e-SOM_i.MX6 - System - On - Module

INDEX

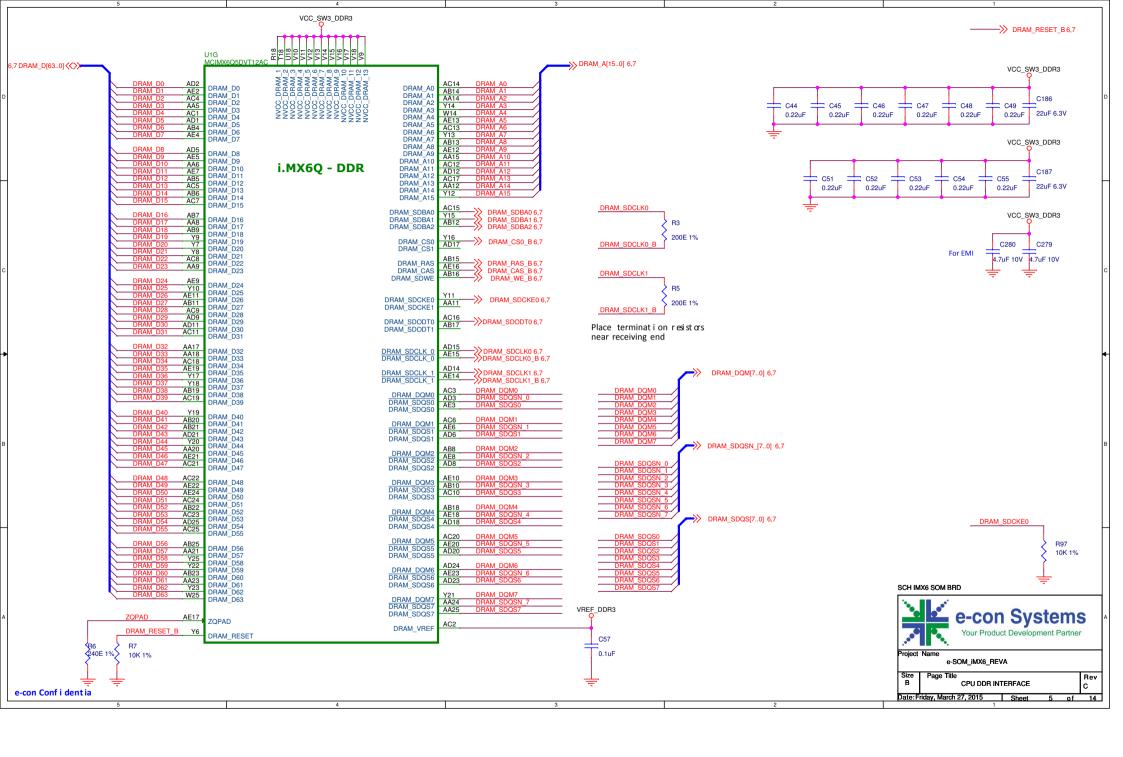
No Date	Descript i on	Remarks
28 OCT	2013 Init i d Rel eas e	
24 SEP 2	1. Pg.No.4 Removed R135, FB15 and FB16 in pg no.4 2. Pg.No.8 Replaced NAND f I ashi rt efface with e MMC Connected UART3_CT5 to ball D15 Removed FB17 and FB18 Changed R74 and R75 values to 510 ohm 3. Pg.No.10 Connected UART3_RT5 to ball D25 Added resistor R167 to ball F23 Set R68 and R103 to NS 4. Pg.No.11 Changed R49 value to 12.1k ohm Set R99 and R100 to mount 5. Pg.No.12 Added resistor R166 to SOM connector pin no.20 6. Pg.No.13 Added resistor R164, R168 and R169 resistors Removed resistors R10, R112, R114 and R130 Mounted R104 and no mount R67 Removed 3.3V Power Switch sect i on	
26 MAR	T Pg.No.09 R182 R183 R184 R185 are added to give swapping opti onfor LVDS1_DAT3 and D8_DAT1 ares	
		optionTorLVLbi_DAI3 and Ds_DAIIIanes
